Re: 10CFR50, Appendix R,  
ISAP Topic 1.64

Haddam Neck Plant  
New Switchgear Building  
Response to Request for Additional Information

Attachment 1  
Haddam Neck Plant  
Response to Request for Additional Information

# UPS MAINTENANCE BYPASS SWITCHING SCHEME

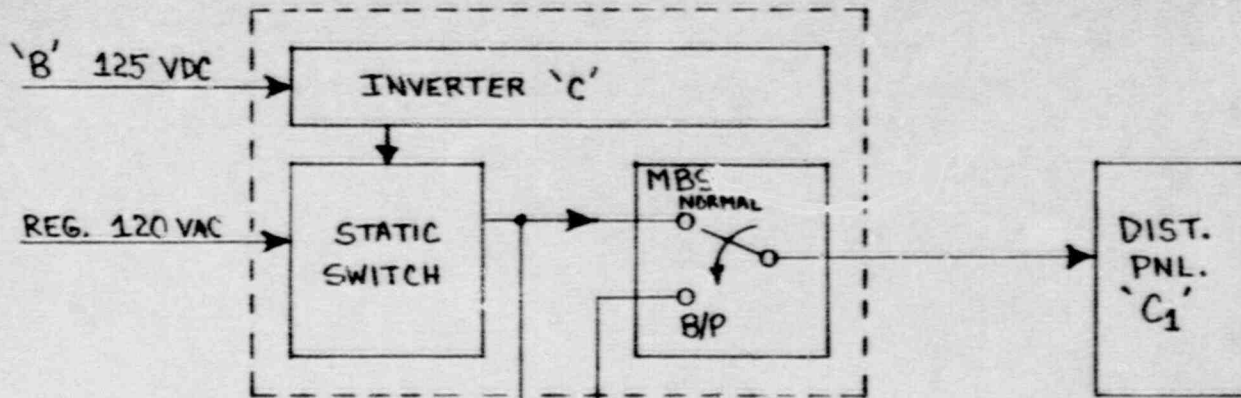
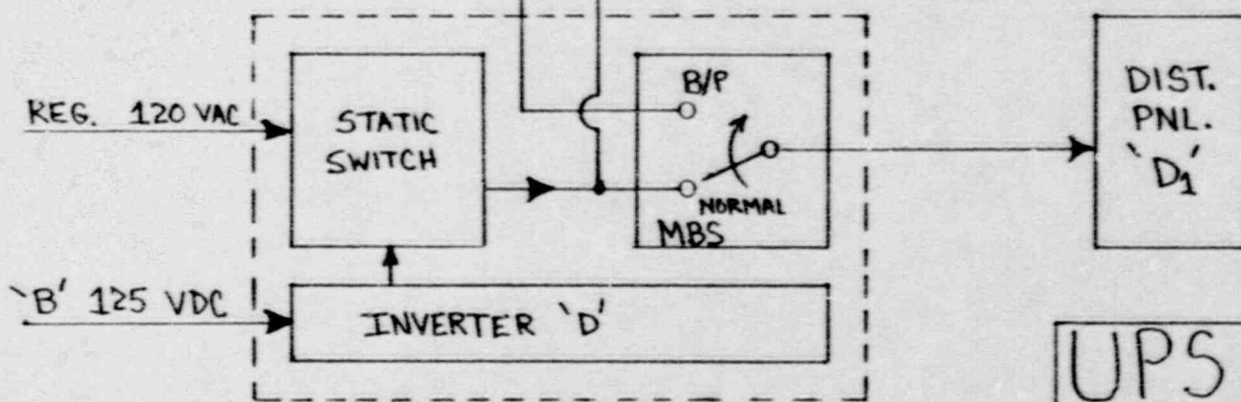
Provide a written description of the switching scheme for vital AC buses C<sub>1</sub> and D<sub>1</sub> along with a supporting diagram.

Attached is a simplified diagram depicting the Maintenance Bypass Switching (MBS) Scheme contained within vital AC Uninterruptible Power Supplies (UPS) "C" and "D." This scheme makes possible the temporary backup of one UPS with the output of the other, as permitted under Technical Specification 3.8.3.1. This feature allows switching between vital AC supplies of the same ("B" Division) battery. The switch utilizes "break-before-make" contacts to prohibit the unintended paralleling of the outputs of the two vital supplies. In addition, the off-normal position of the switch is alarmed in the control room as part of a common "trouble" alarm for the vital AC supplies.

Technical Specification 3.8.3.1 allows use of this scheme so long as the reactor protection trip signals for the inoperable supply are manually placed in the trip condition. A maximum operating time of 72 hours is allowed in this mode.
